DEPARTMENT OF THE ARMY  
U.S. ARMY ENGINEER DISTRICT, SACRAMENTO  
CORPS OF ENGINEERS  
1325 J STREET  
SACRAMENTO, CALIFORNIA 95814-2922

Regulatory Branch (199450397)

This letter is in regard to your company's need for compliance with the terms of our permit no. 199450397, issued to allow the relocation of a section of Willow Creek near Helper in Carbon County, Utah.

RE: YOUR LETTER DATED NOVEMBER 12, 1997 - PERMIT 199450397

# Willow Creek Weir Flow

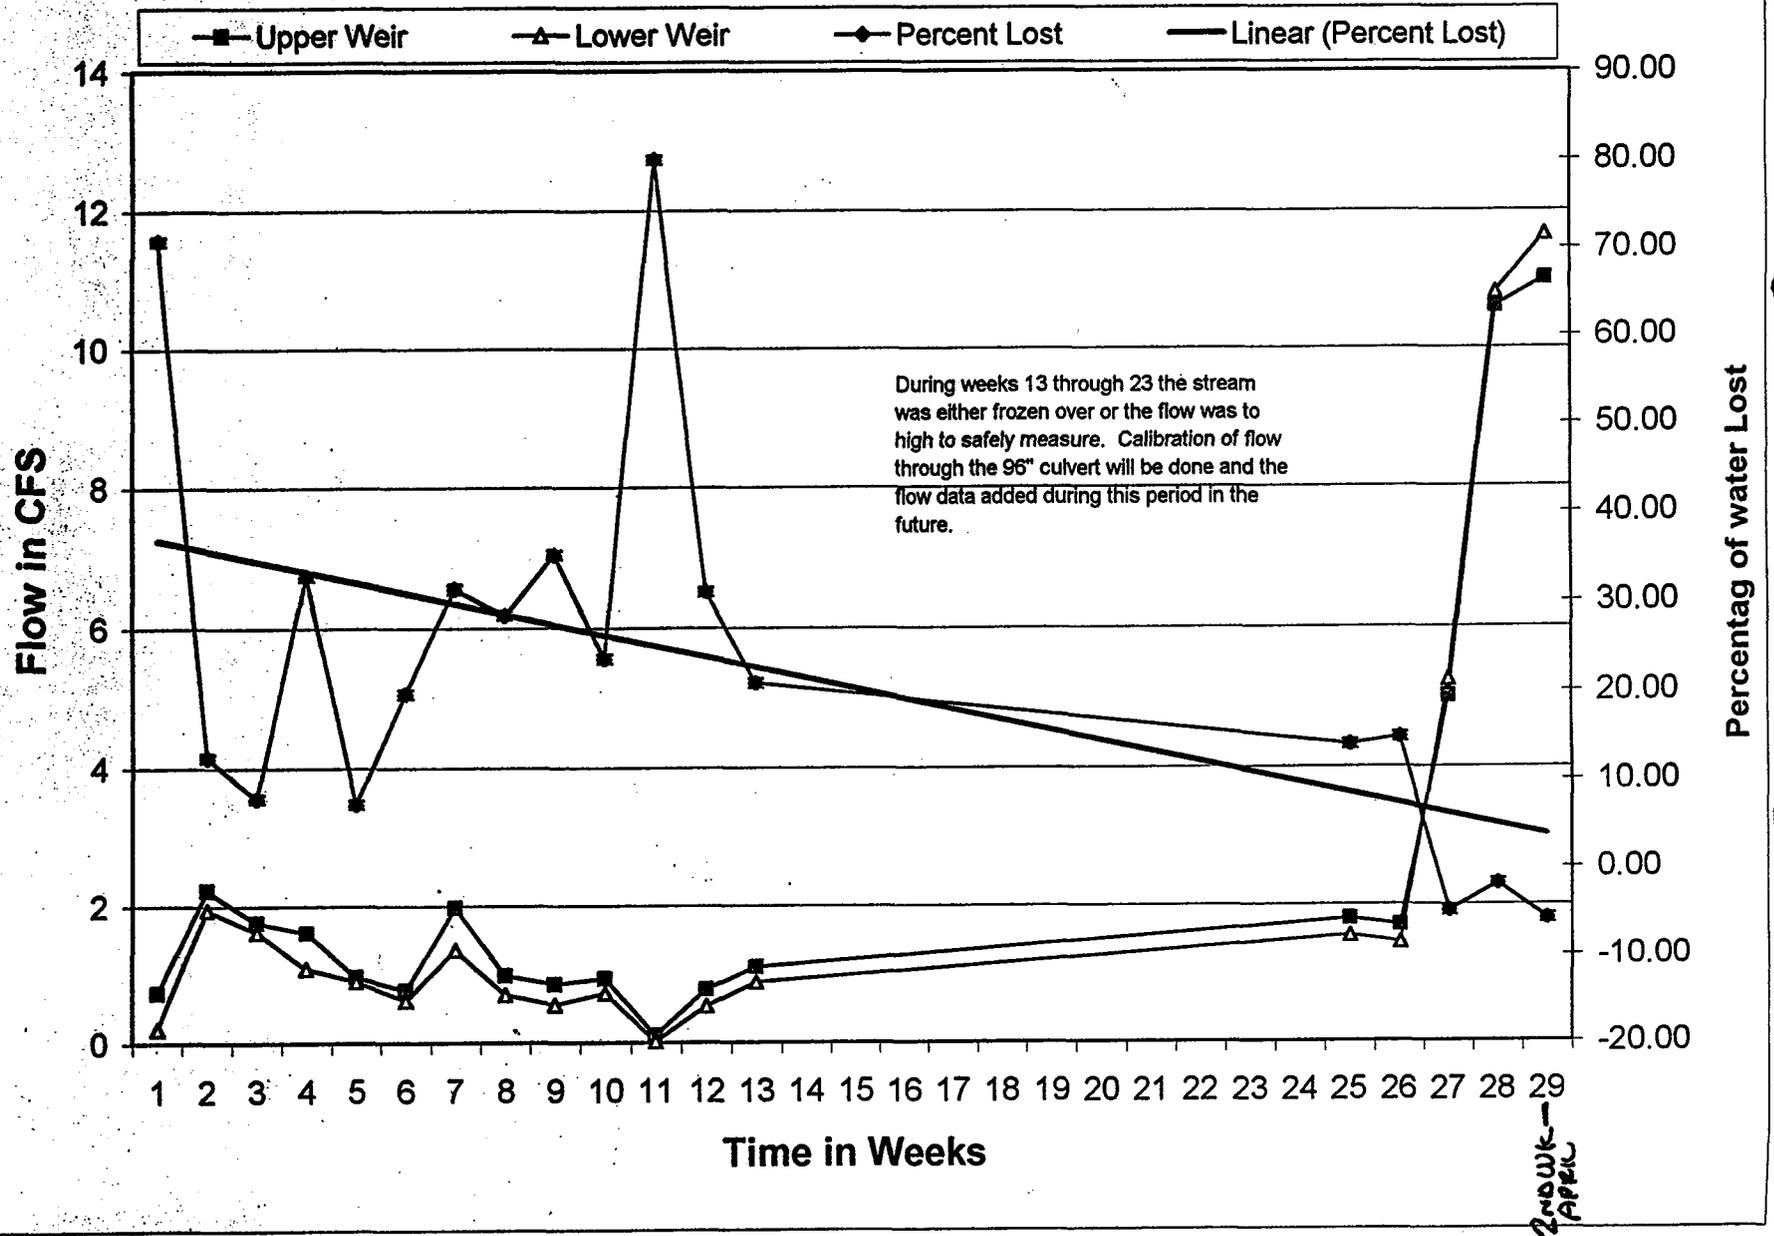
The attached graph titled Willow Creek Weir Flow presents the monitoring data from two weirs installed in Willow Creek, one above the stream relocations sections called the "Upper Weir", and one below the stream relocation called the "Lower Weir".

As can be seen on the attached graph, the percentage of water loss from the upper weir to the lower weir appears to be declining. If this is in fact happening, it would indicate that the riprap channel lining is filling in with silt allowing less water loss to the ground. Continued monitoring will give additional data for evaluation. It must be recognized though that even in the natural stream some water loss is often possible, and the loss between the weirs may never be zero.

Photo #1 (top) and #2 (bottom). Designed habitat features in upper stretch of relocated Willow Creek, July 1996. Rock dams (top) and rock overhangs and individually placed boulders (bottom) are noted.

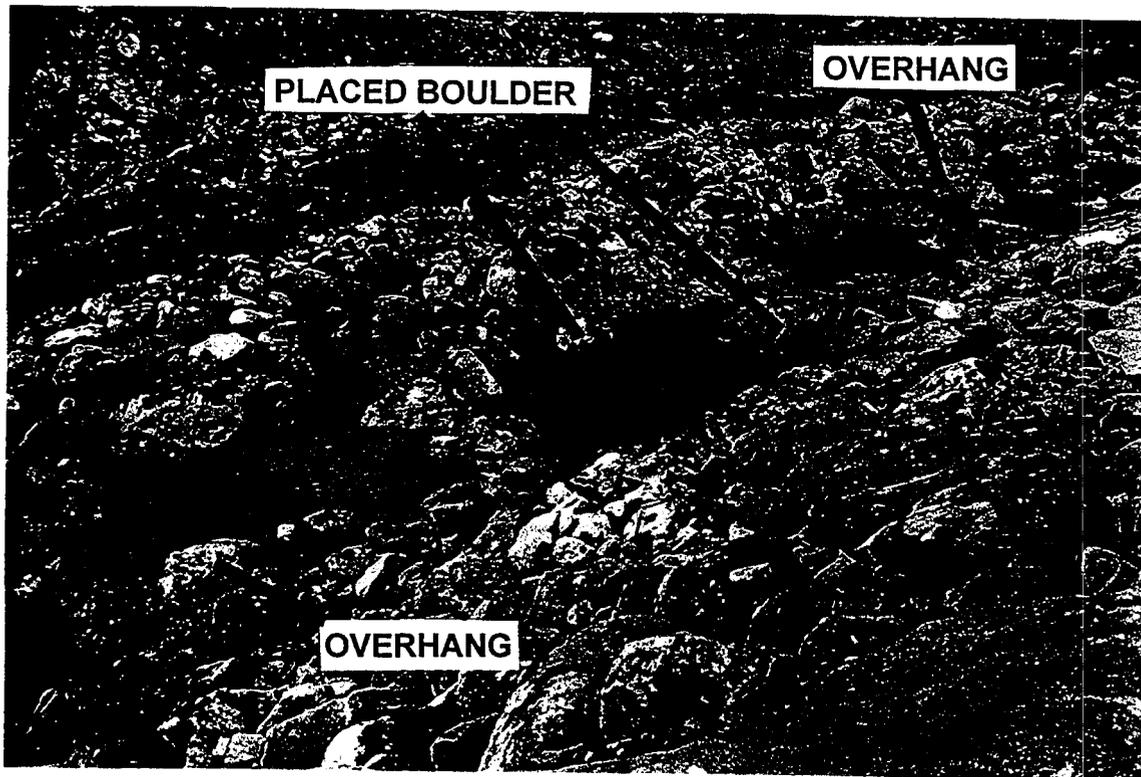
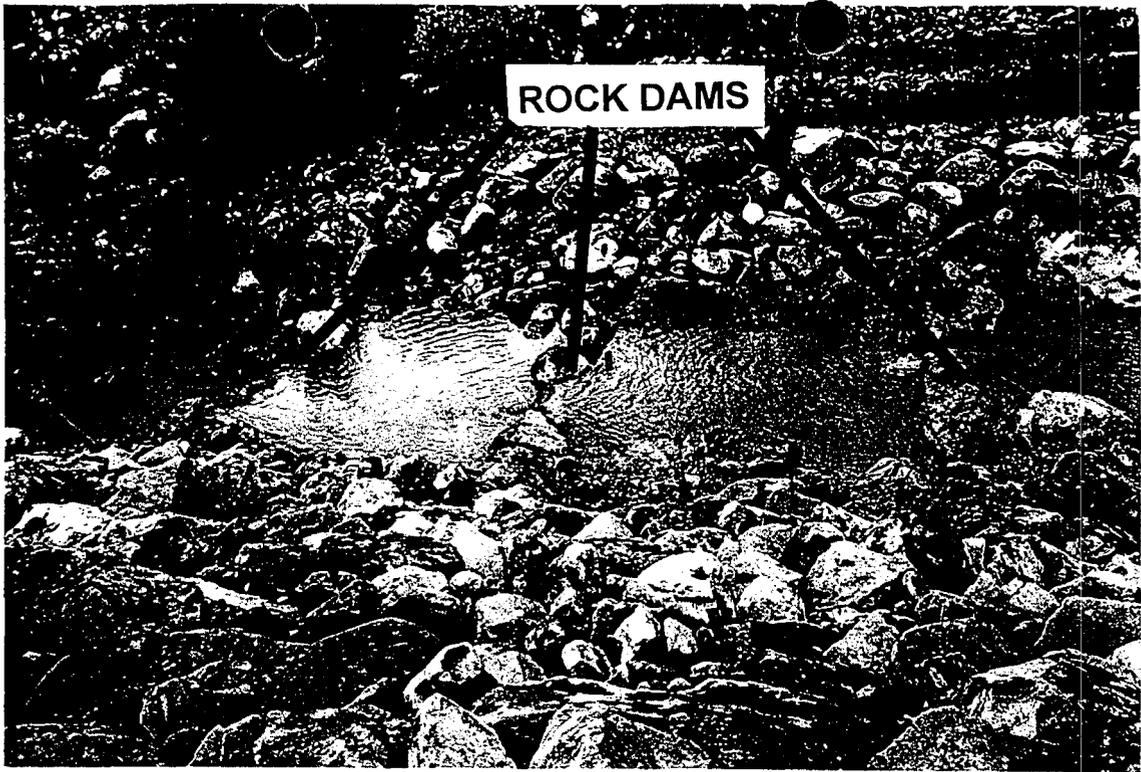
SWCA personnel (Mark Raming and I) have been involved with the Willow Creek relocation since just before construction began. We reviewed the relocated stream channel design prior to construction (including soliciting review and input from Dr. John C. Schmidt, Logan, Utah) (SWCA 1996). We were also present during construction of the new channel and supervised the creation and incorporation of several types of habitat features into the new channel. One of the main design features we used repeatedly was a rock dam constructed from a row of 4'-7' diameter boulders imbedded perpendicularly into the riprap layer, causing water to fill a pool constructed upstream from the dam, spill over the dam's top, and plunge downstream (see photo #1). Approximately 50 of these rock dams were installed in the relocated stretches of Willow Creek. The plunges associated with each boulder dam were designed to be <12" in height to allow for fish passage. Other design features were individually placed boulders and rock overhangs, to allow for shade and habitat diversity (see photo #2).

The rock dams designed to form pools and plunges appear to be functioning properly. Before the autumn precipitation began, flow was passing around (as well as over) the dams through voids in the riprap and smaller rock. As autumn progressed, however, more water began to spill over the rock dams, indicating sealing of the pools and dams.
